35/54-92B 8806 Hawkins Lane

APPLICATION FOR HISTORIC AREA WORK PERMIT

HISTORIC PRESERVATION COMMISSION STAFF REPORT

Address: 8806 Hawkins Lane Meeting Date: 8/12/92
Resource: Hawkins Lane Hist. District Review: HAWP/Alt.
Case Number: 35/54-92B Tax Credit: No
Public Notice: 7/29/92 Report Date: 8/5/92
Applicants: C. Johnson/C. Ellison Staff: Nancy Witherell

EAST ELEVATION

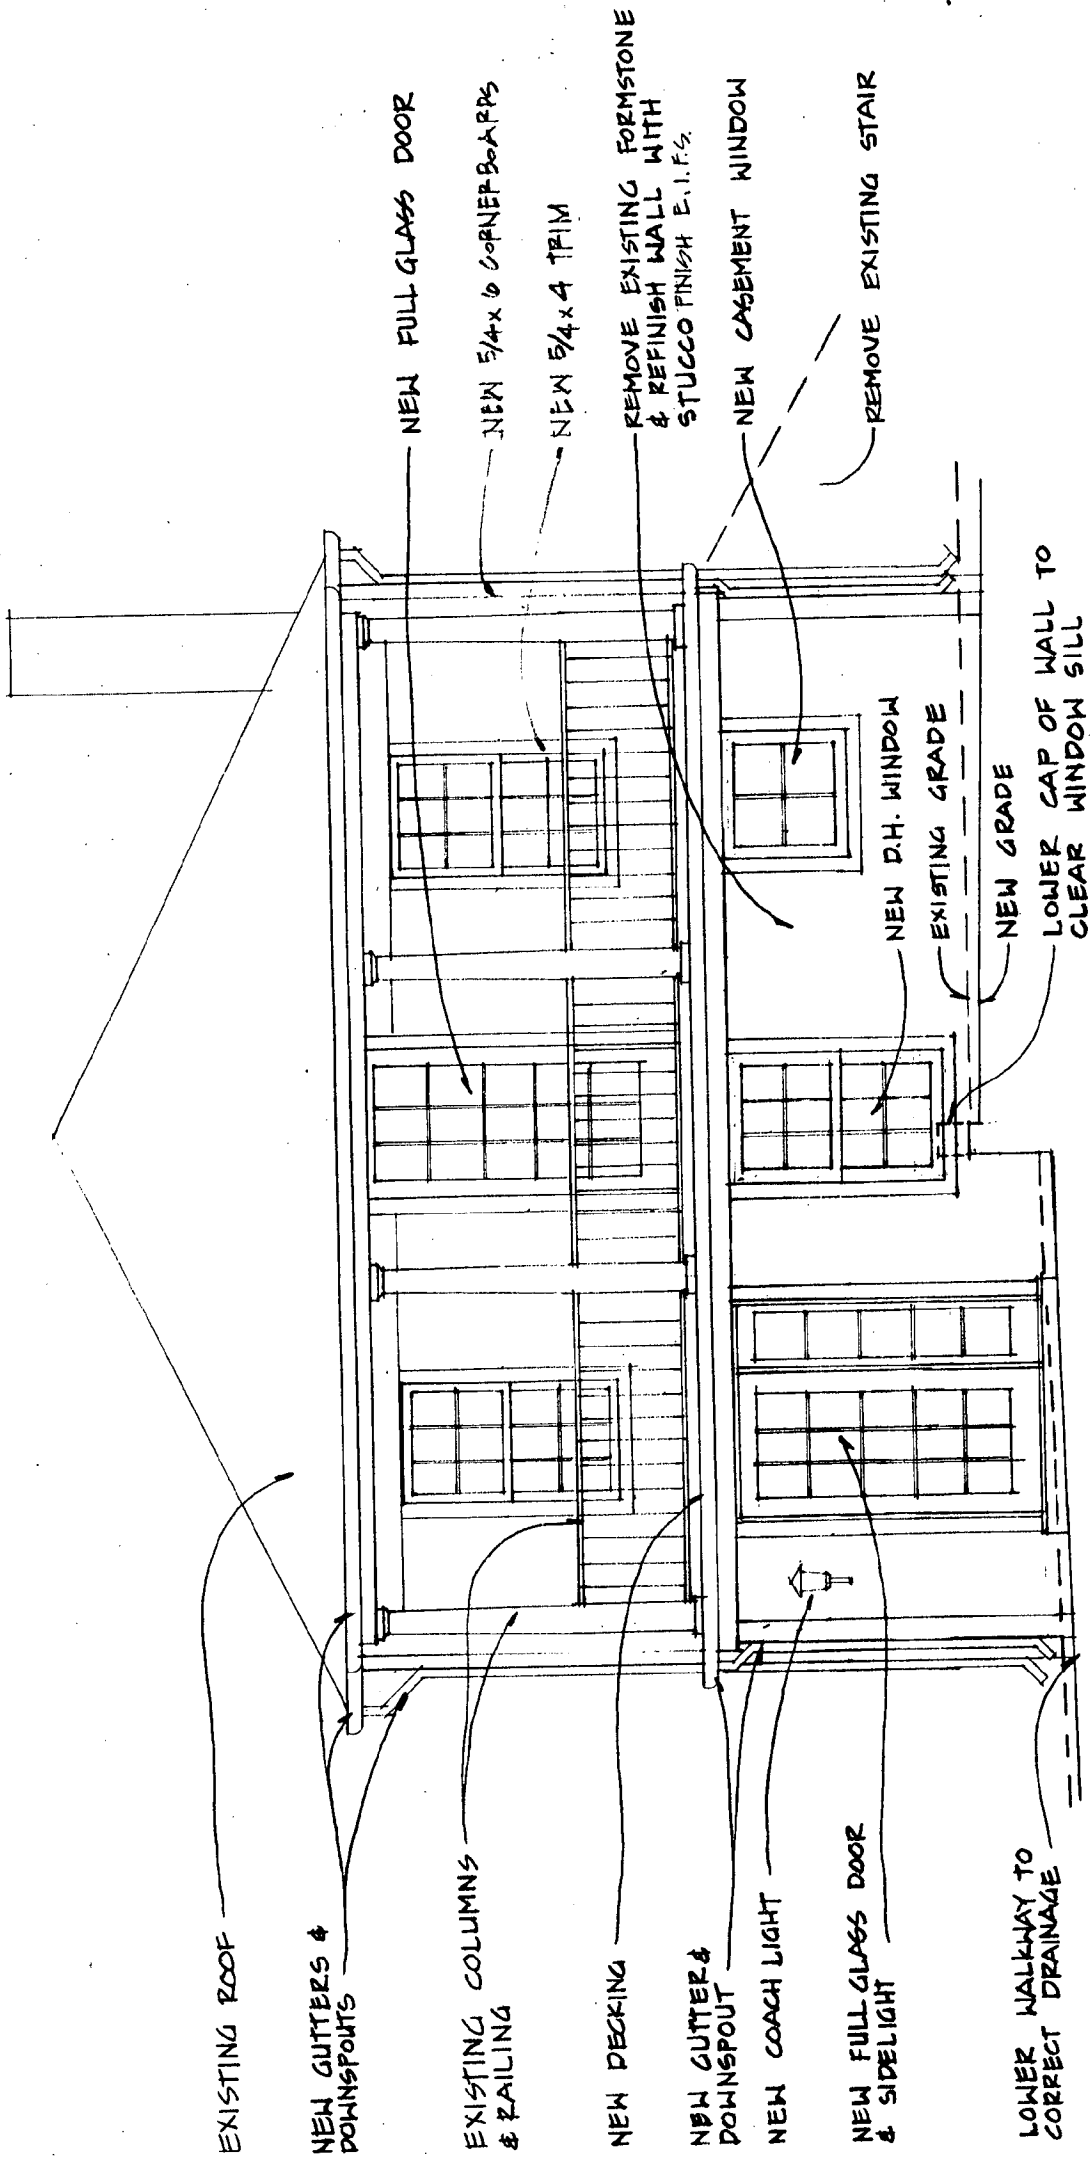
JOHNSON/ELLISON - PROPOSED
 *REVISED PER HPO RECOMMENDATIONS 8.17.92

The proposed changes to the front facade, aside from the material change and the removal of the stairs, would include alterations to the fenestration. The front door on the ground floor would remain in the left bay of the facade, but would be emphasized by the use of a glass door and sidelights. A double-hung window and a casement window would be installed where no openings exist. Double-hung windows would be added on the side and rear elevations. The existing door on the second floor would be replaced with a multi-paned glass door.

The staff recognizes that one of the purposes of the project is to increase the amount of light reaching the ground floor living room. Nevertheless, the staff is concerned with the formality of the proposed front door and sidelights. Given the additional windows proposed for the vestibule, the staff recommends that the sidelights be eliminated so that the door width is similar to that of the other fenestration openings on the front facade.

The staff recommends that the HPC approve the proposed alterations with one condition related to the new front door.

FIRST FLOOR PLAN

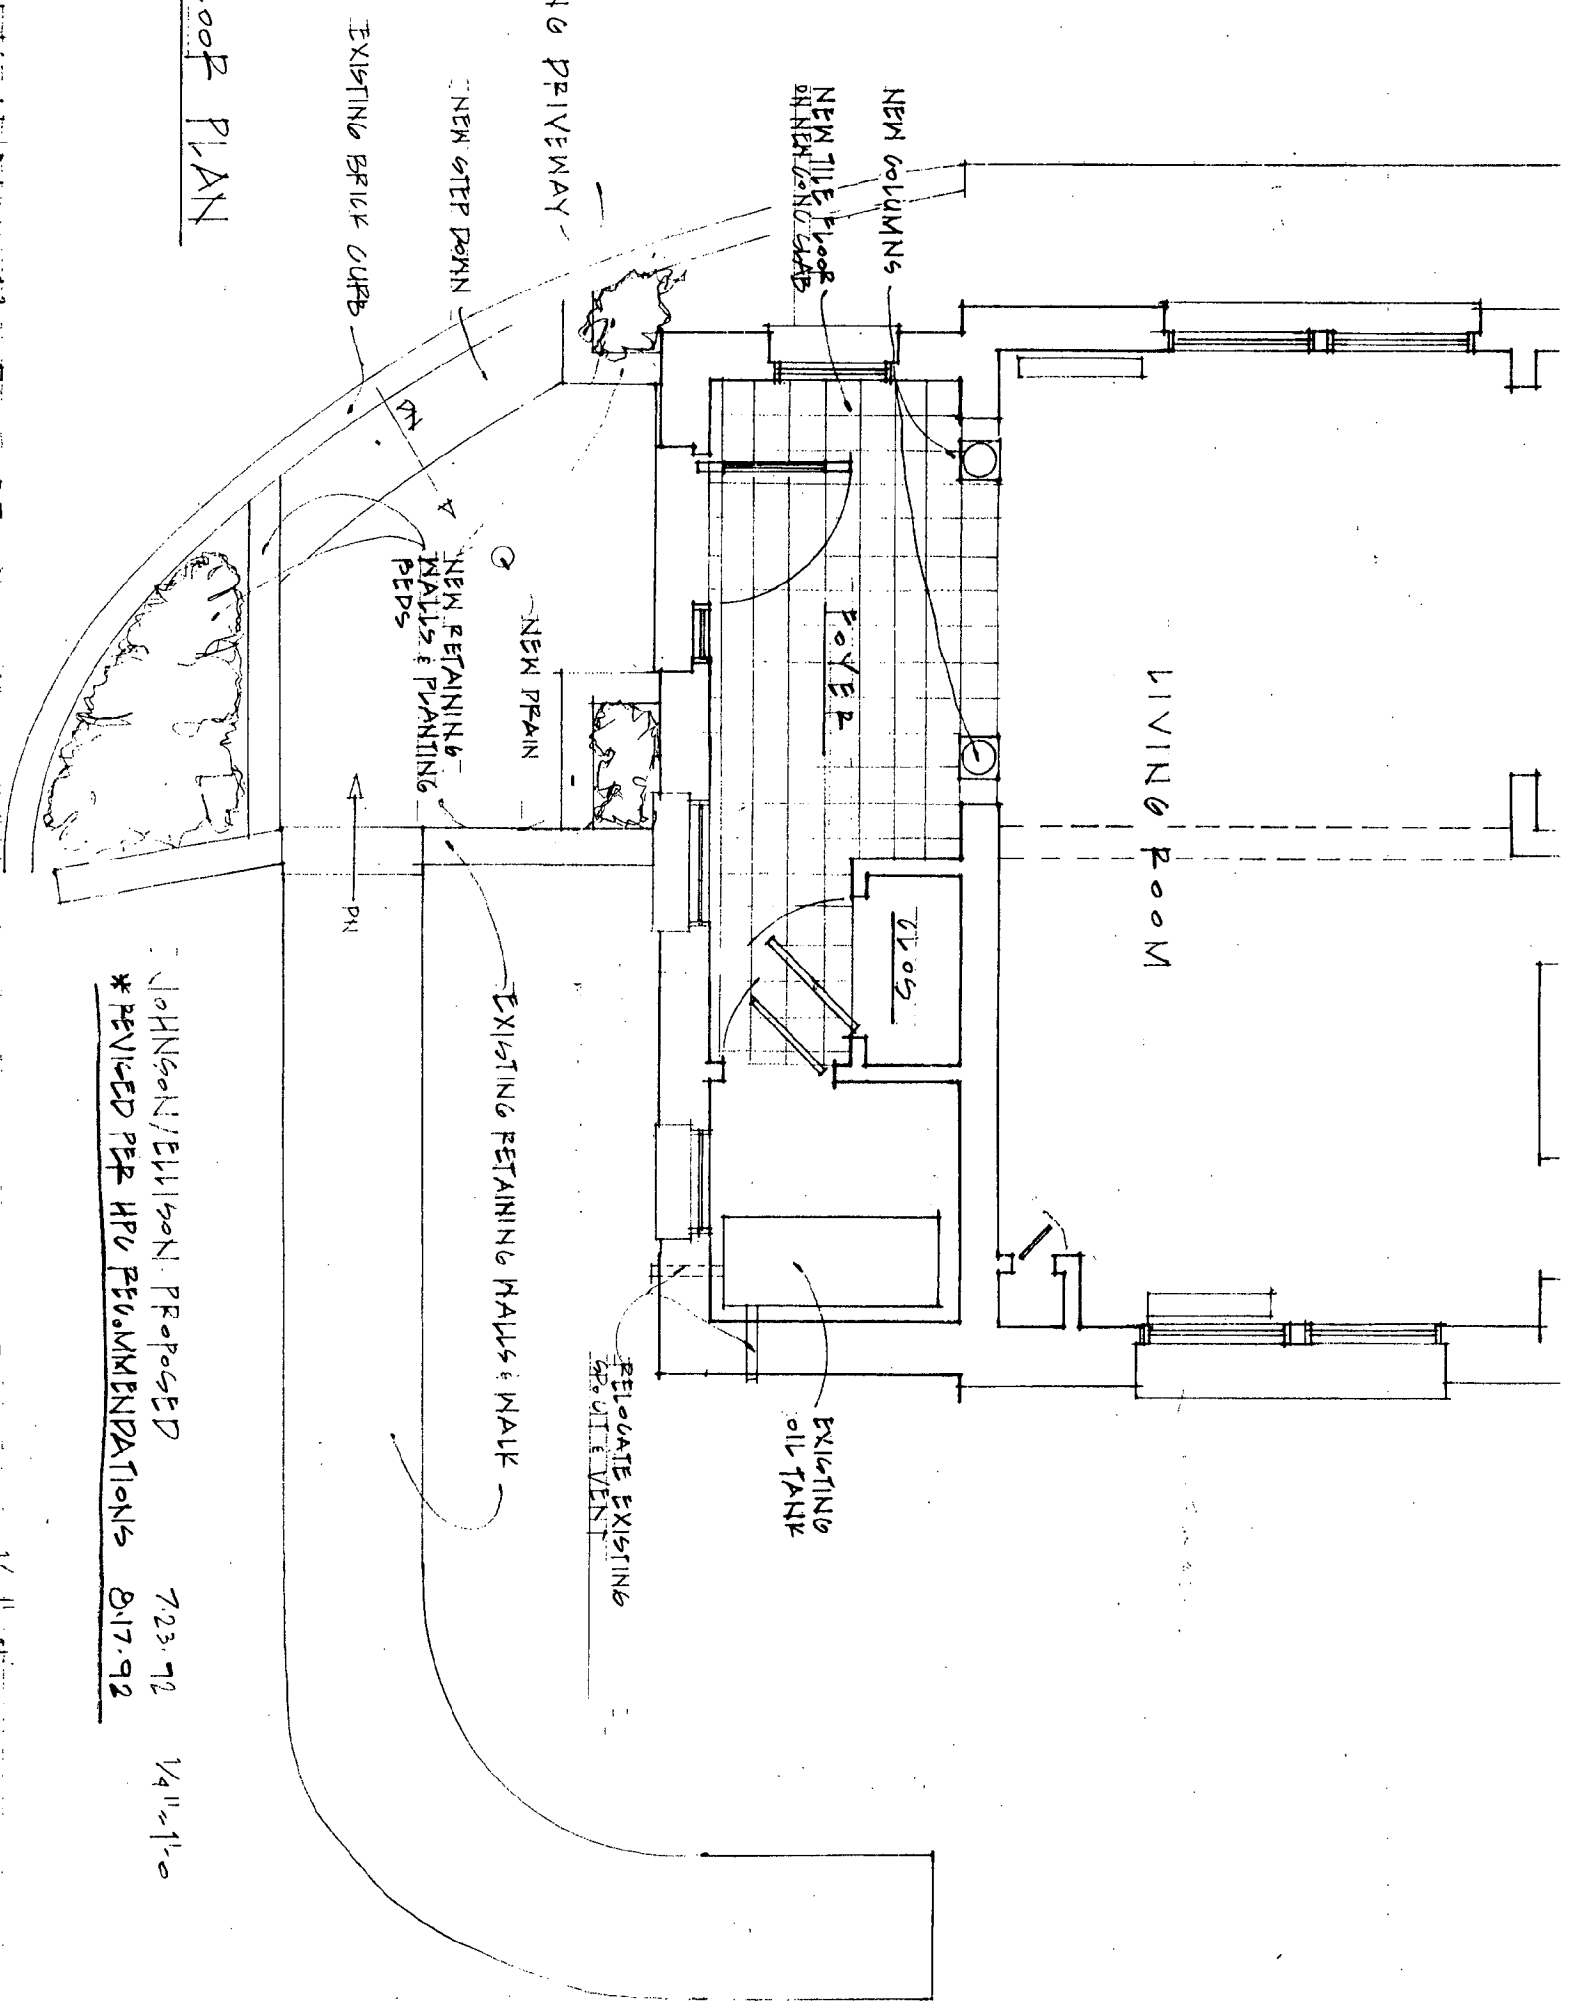
JOHNSON/ELISON PROPOSED
* REVISED PER HPC PERMITS 8/17/92

EAST ELEVATION

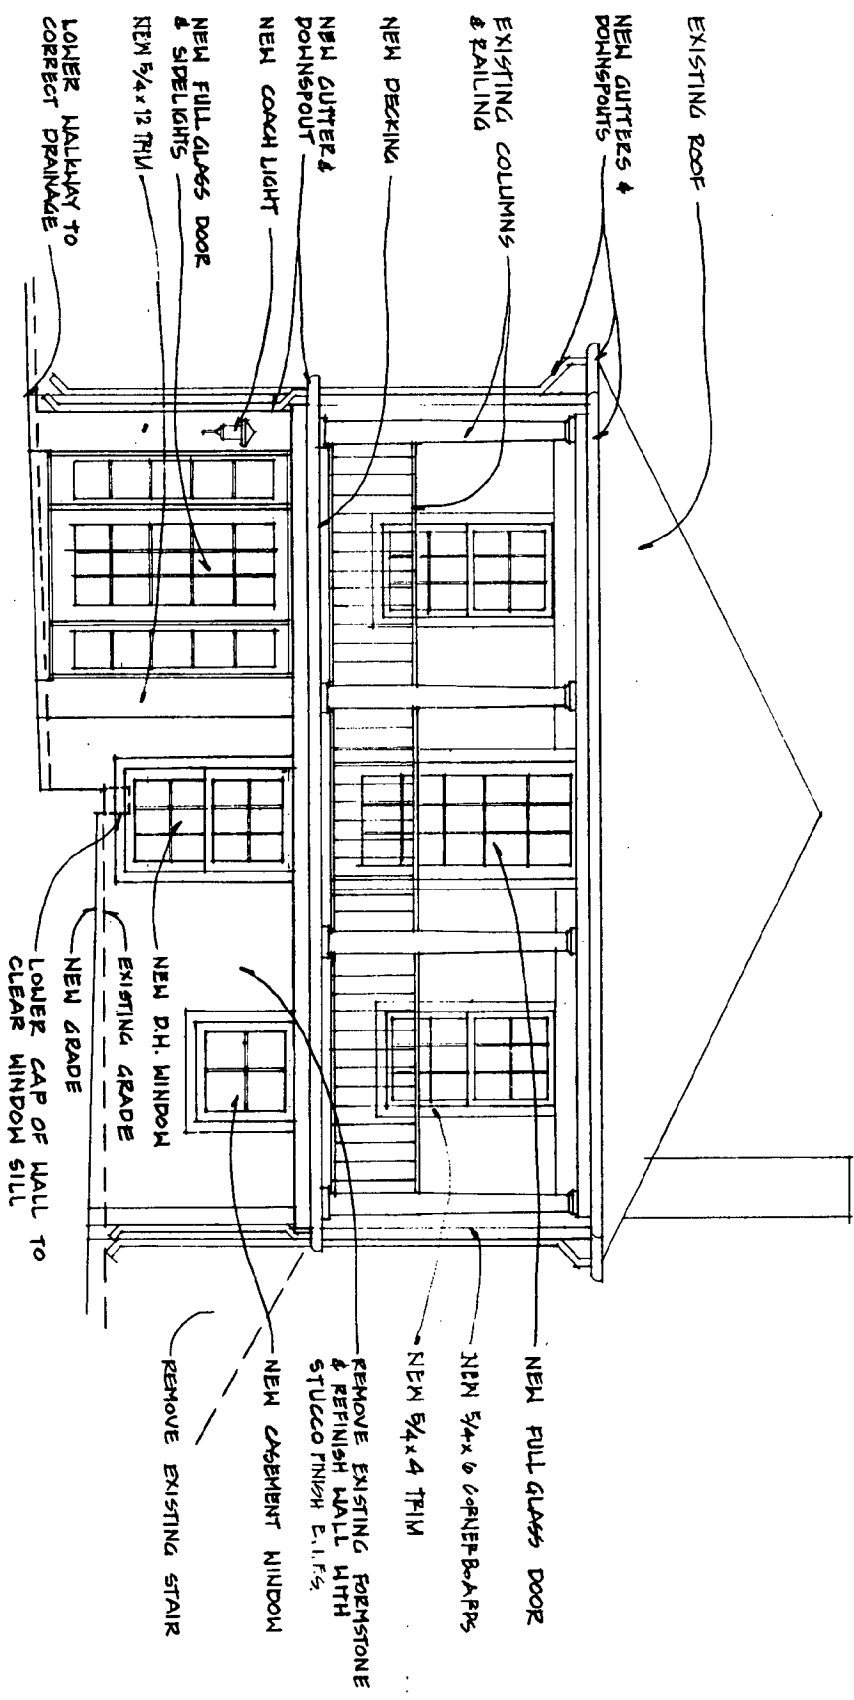
The removal of the formstone and aluminum siding, non-original materials, is appropriate as long as the installation of the Dri-vit achieves a simple appearance similar to that of parging. The application of 5/4" corner boards and window trim diverges from the appearance of parged block; staff considers it an acceptable alteration.

The removal of the staircase fundamentally changes the approach to the house, visually if not in fact. In this instance, considering the poor physical condition of the staircase, and the fact that it has not been used for many years following the alteration of the internal plan of the house, the staff recommends that the applicants' request to remove it be approved.
